FIELD CHANGE ORDER

PAGE 1	OF 1
RE ECN NO.	17-014

MANUFACTURING EFFECTUATION DSC801/39,40,43 and upwards.	EQUIPMENT AFFECTED RC 8000 RC 8200 / DSC 801 Disc Storage Controller.
NOTE

Correction of Bus-out parity during write operations.

Circuit: KT 214 (Pull - down resistors + transistor)

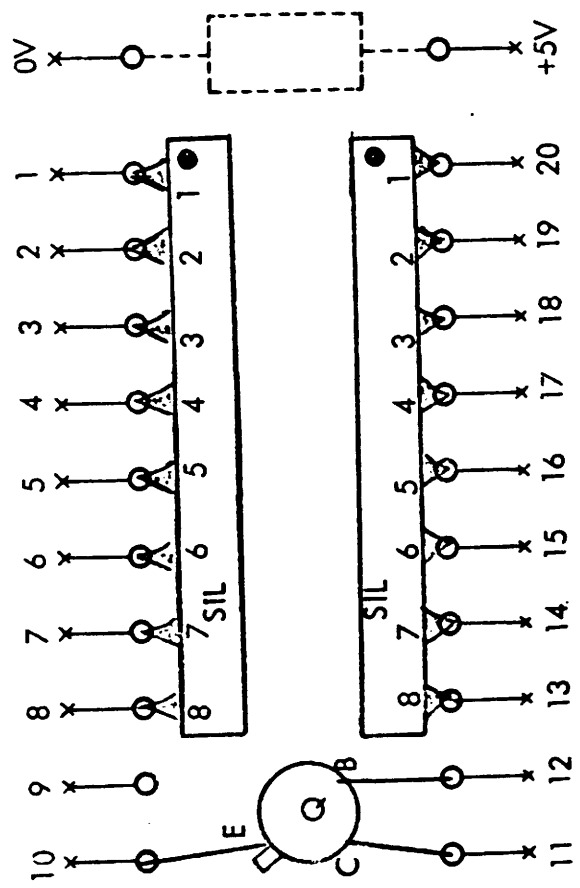
Change in DSC 801 preventing latch up of handshake flip flop, and ensuring reliable Disc-powerup and autoload.

1. Execute the wiring changes as shown the enclosed hardoc formula.
2. In position 3 substitute 56Ω resistor with a 2N2222A emitter in pin 10, collector in pin 11, base in pin 12. (Position 3 is changed to circuit no KT 214, see page 4)
3. Code the FCO-label 17 - 017.

Provisional logic diagram
(1 page)

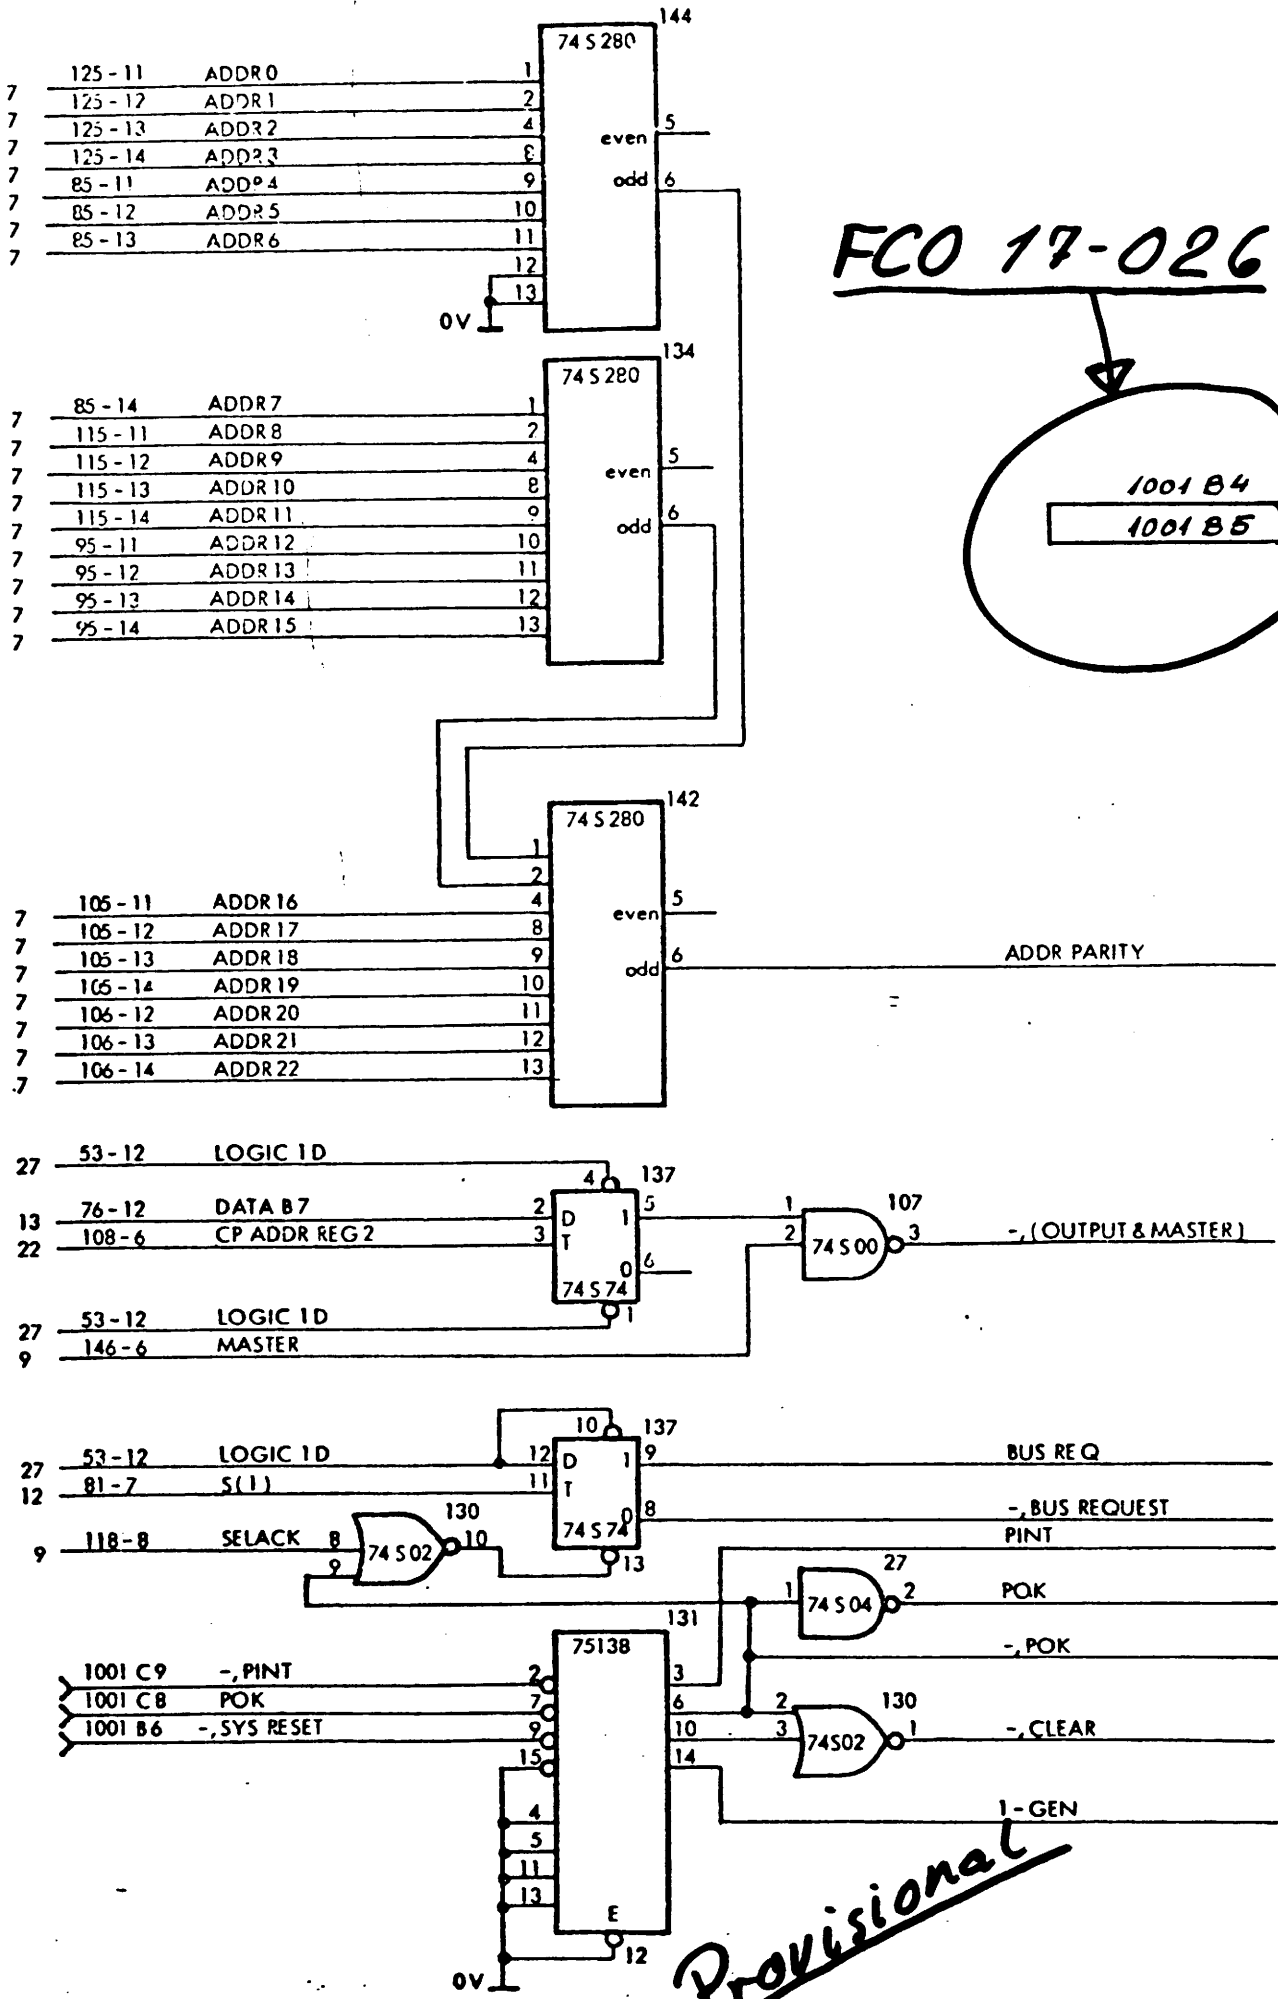
Enabling the use of DSC801 in the CPU-chassis, by bypassing the CPU-priority signal.

- Wrap the connection 1001B4 - 1001B5
- Code the FCO-label 17-026

Modification formular
Hardwaredocumentation

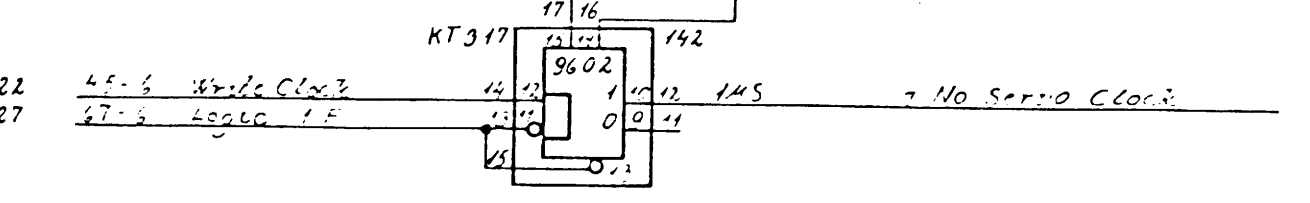
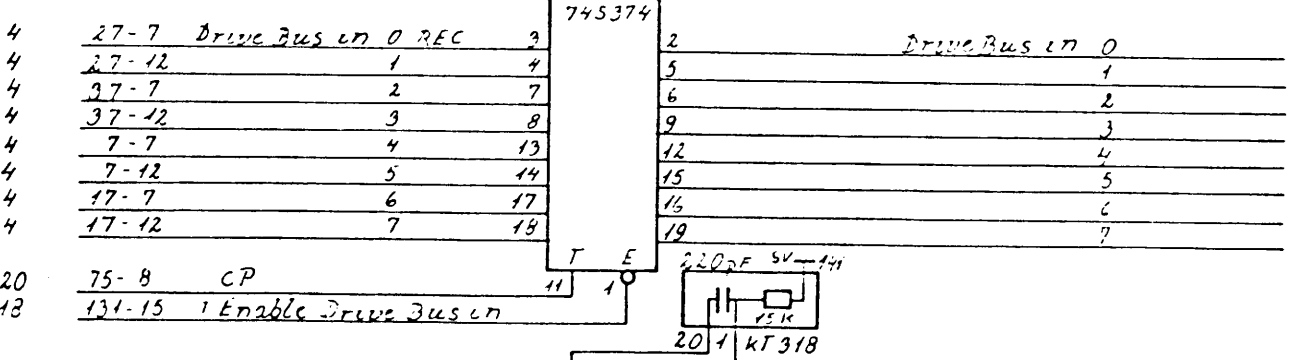
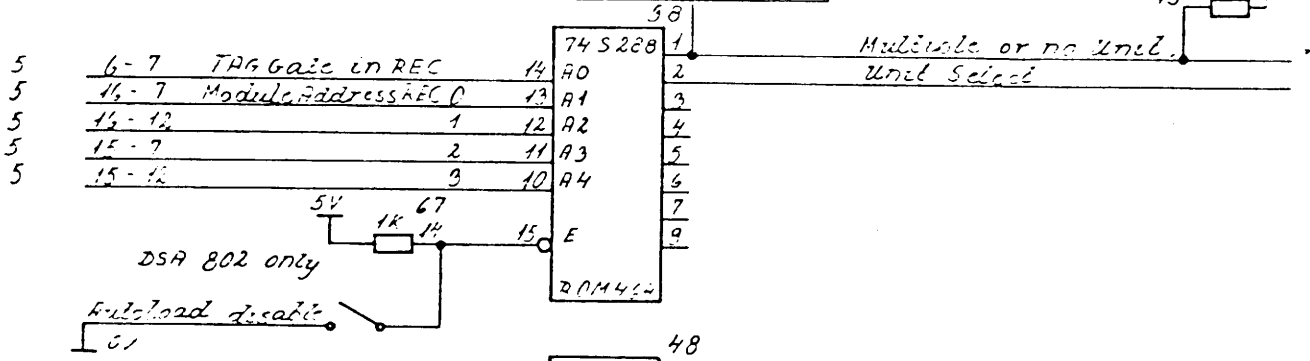
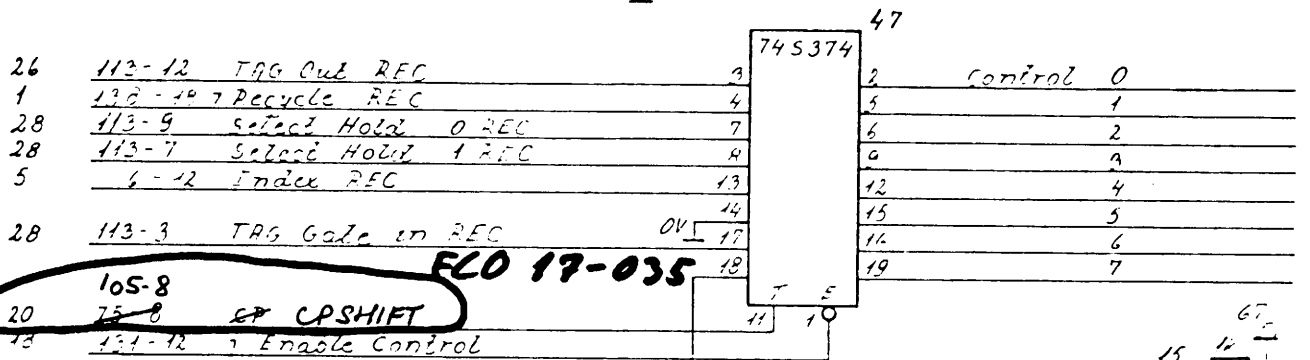
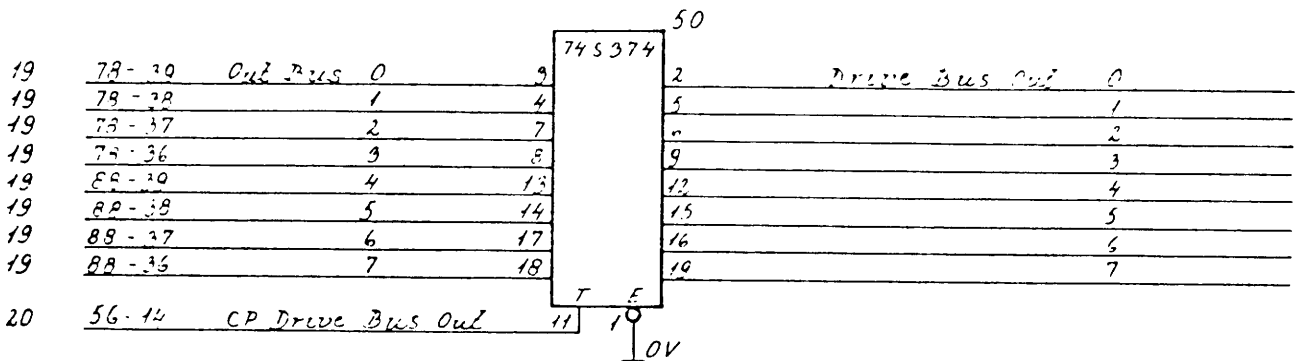
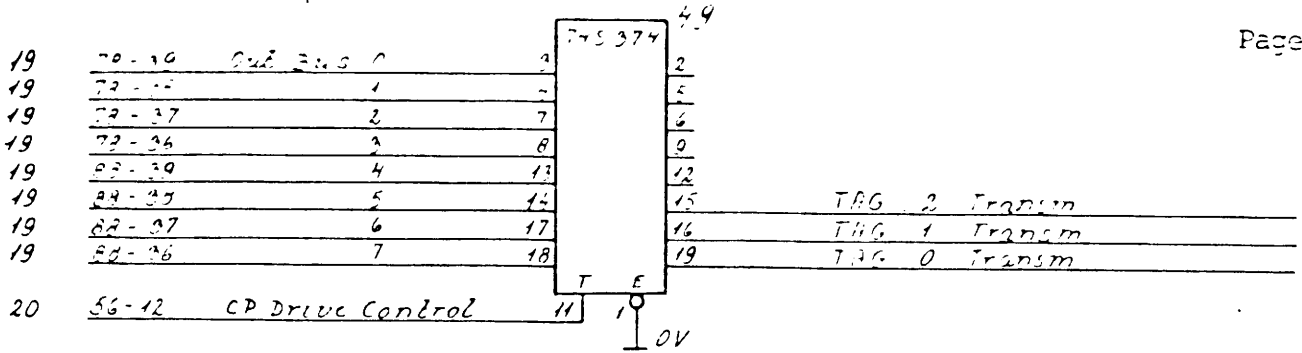
Disc channels with 4 storage modules may have difficulty in communicating with the last disc on the chain. This is caused by noise on the "tag gate in" signal on cable A, giving extra delay.

- Execute the wiring changes according to the Hardoc formula (page 2).
- Code the FCO-Label 17-035

Provisional Logic Diagram for FDC 705.

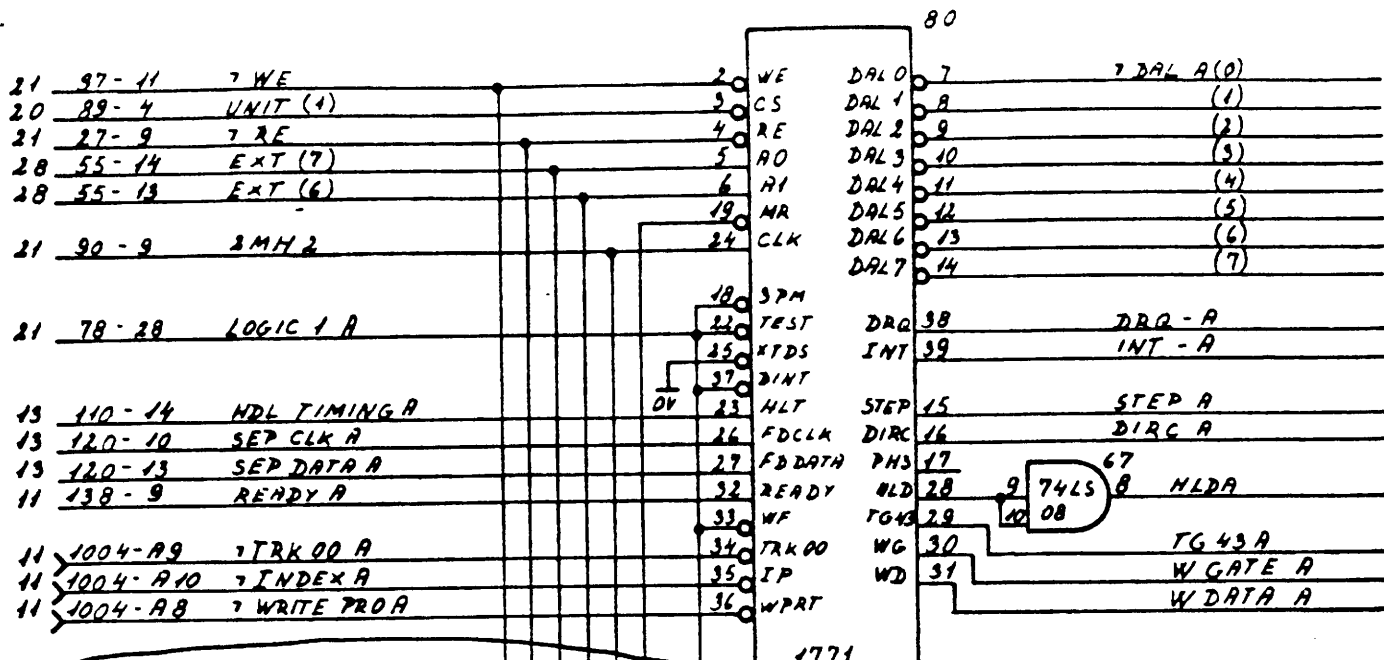
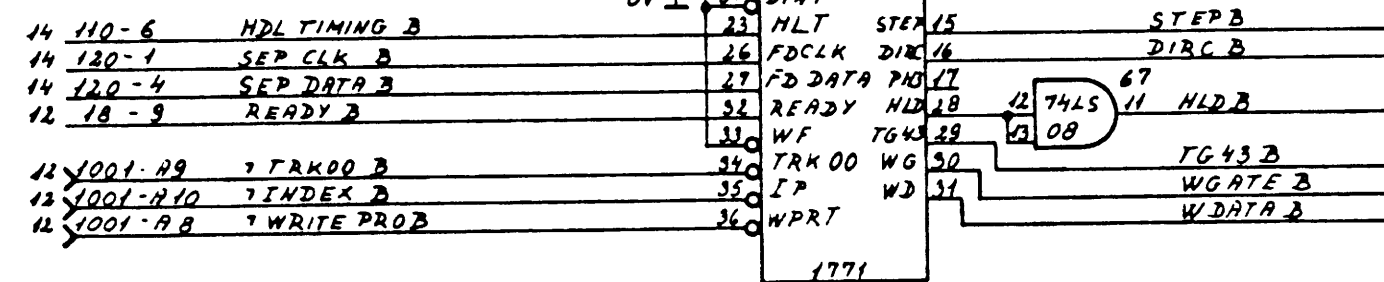
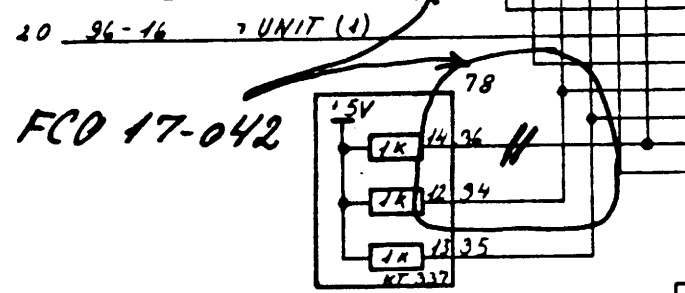
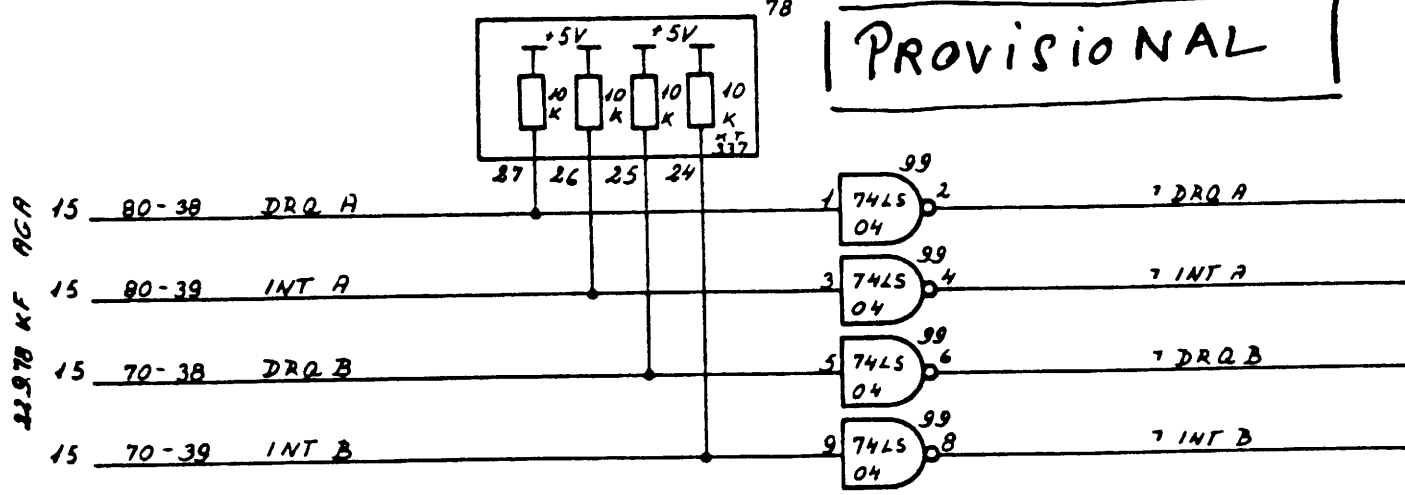
The Master Reset Input pin on Floppy disc controller chips was not previously utilized on the FDC 705. However, in order to prevent Dead-lock in some cases, it has been necessary to provide a Reset-pulse to the chips. This is performed by connecting the Reset-pin to the Bussignal >PINT.

1. Remove the wire : (78-36) → (80-19) → (70-19)
2. Insert the wire : (1003-A28) → (80-19) → (70-19)
3. Code the FCO-Label 17-042
